RE: 1000 Avonoak Terrace
Design Review PDR 1608723

City of Glendale
Community Development Department
Design Review Staff Report – Single Family

Meeting/Decision Date: July 11, 2016	**Address:** 1000 Avonoak Terrace
Review Authority: ☐DRB ☒ADR ☐HPC ☐CC	**APN:** 5665-007-003
Case Number: PDR1608723	**Applicant:** Aram Alajajian
Prepared By: Kathy Duarte	**Owner:** Leslie Nishanian

PLANTING PLAN

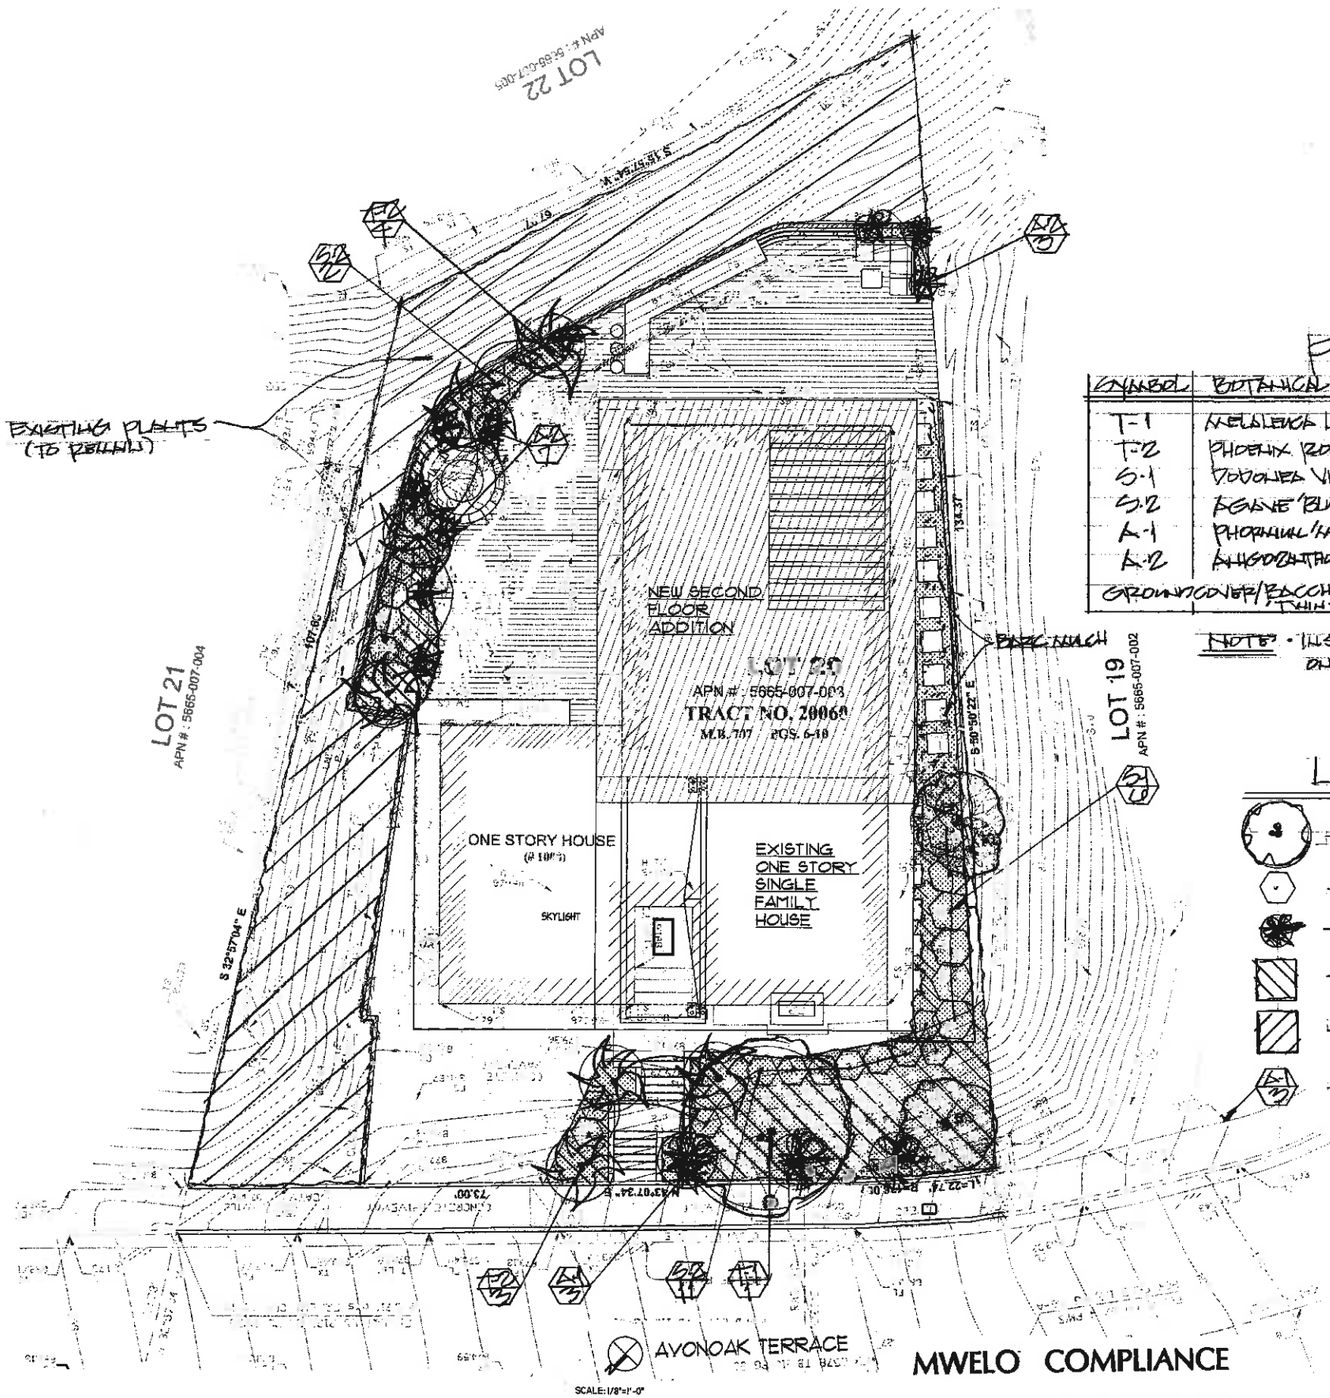
The proposed landscaping is complementary to the building design. However, staff is also recommending a condition that the landscaping on the backyard slopes be replanted with drought tolerant and MWELO compliant landscaping to match or complement the new proposed landscaping and be included on the landscaping plans.
